Number: TSB-FC -2015-033 Various machines, rear wheel hub cracking

Date: Sept. 8th, 2015

ISSUE:

Fig.1

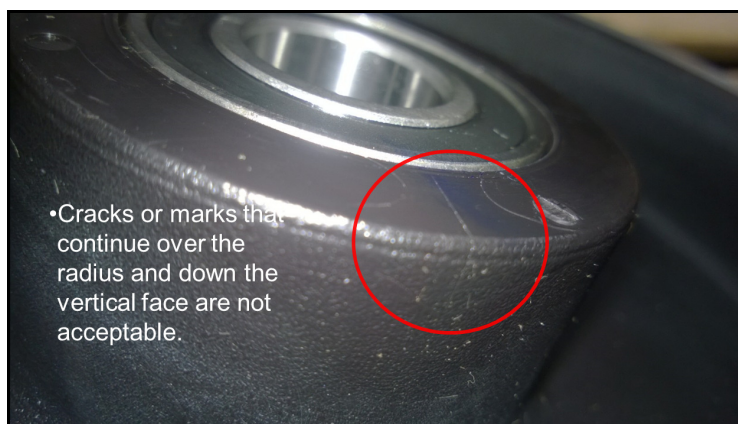
Cracks found on the surface of the round face that do not extend over the hub radius are acceptable (Fig.1) and do not affect the strength of the hub. Hub replacement not necessary.
